# MDDP AMENDMENT & FINAL DRAINAGE REPORT

## MERIDIAN ROAD & BENT GRASS MEADOWS DRIVE

### GALLOWAY RESPONSE

#### Engineering Review

## PROPOSED DRAINAGE MAP

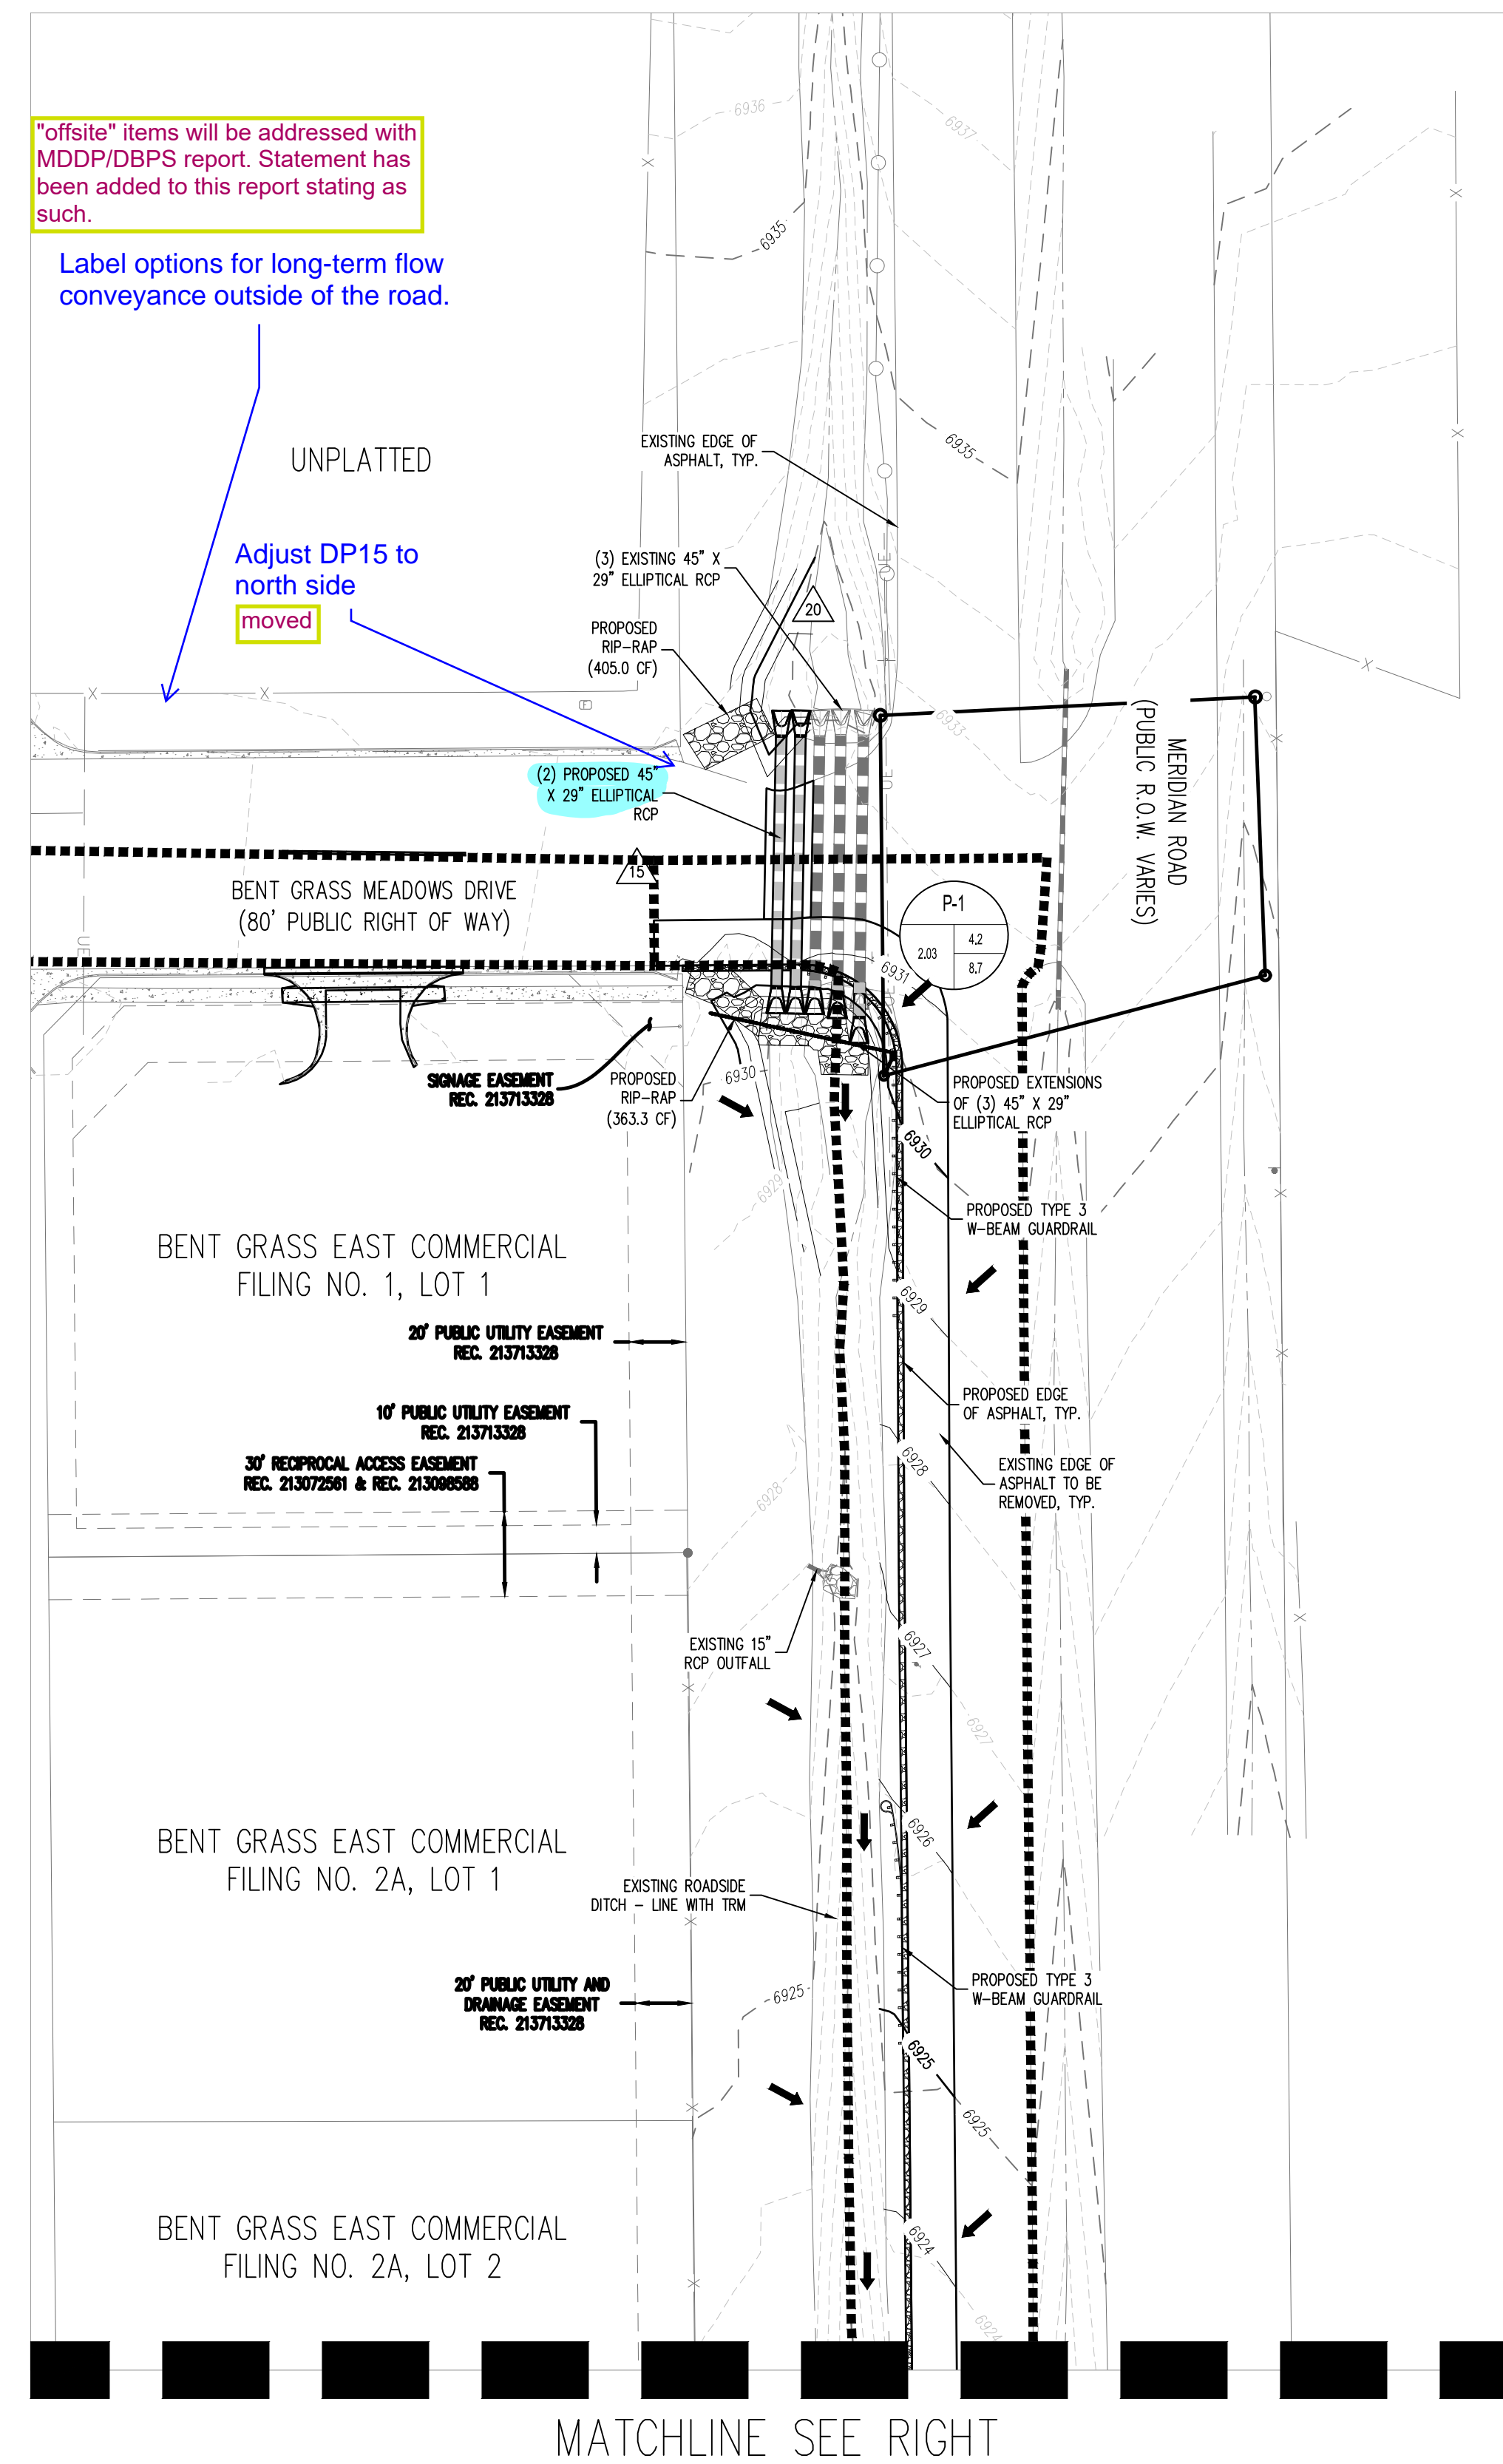
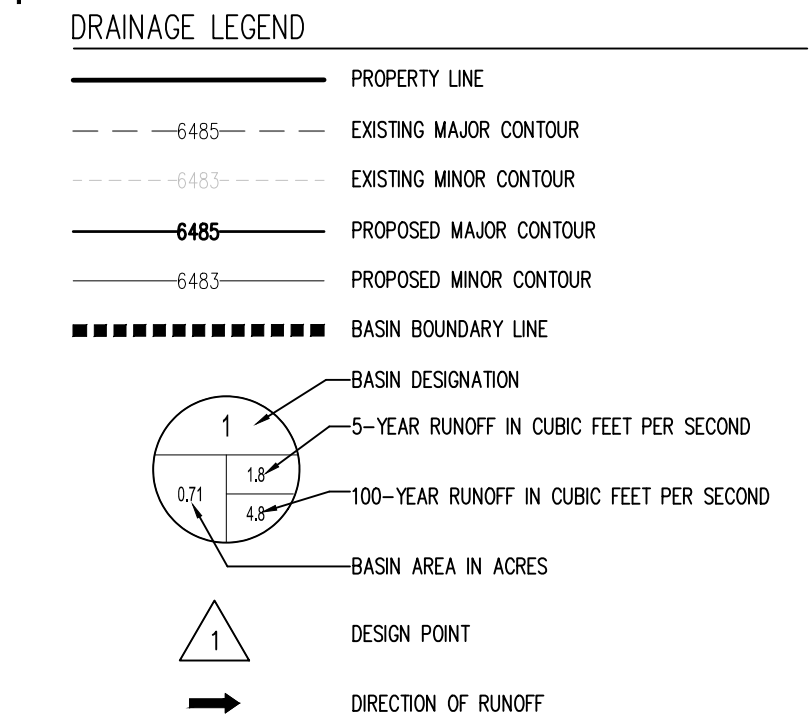
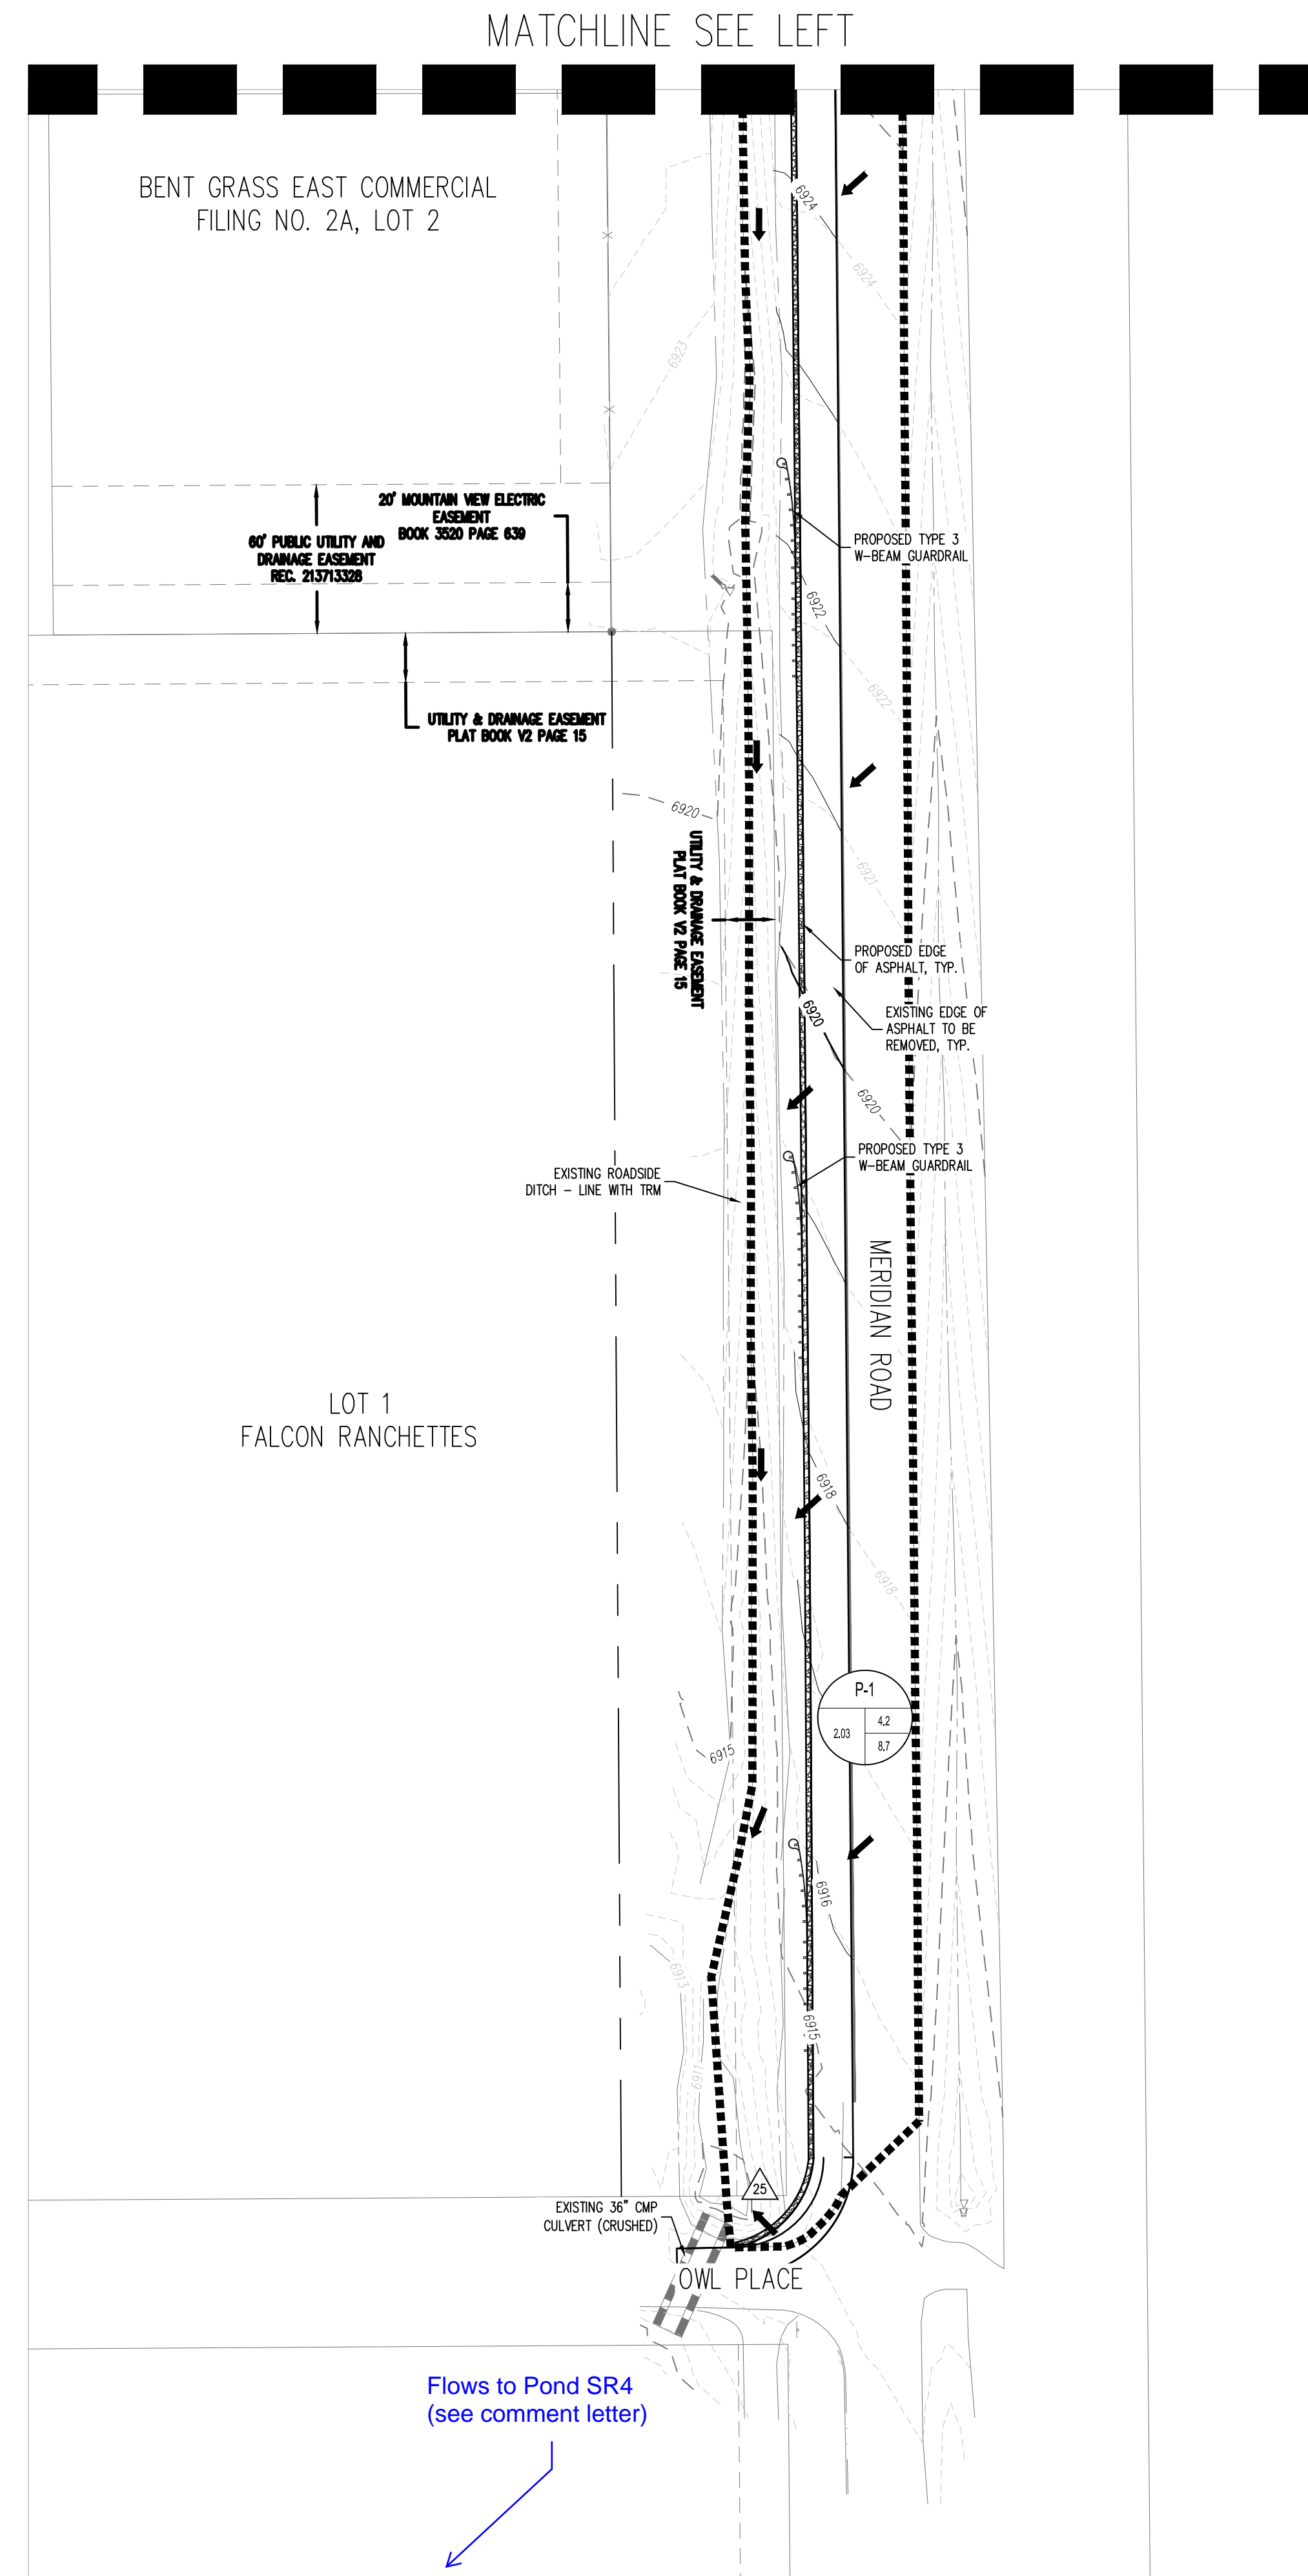
Flows to Pond SR4  
(see comment letter)
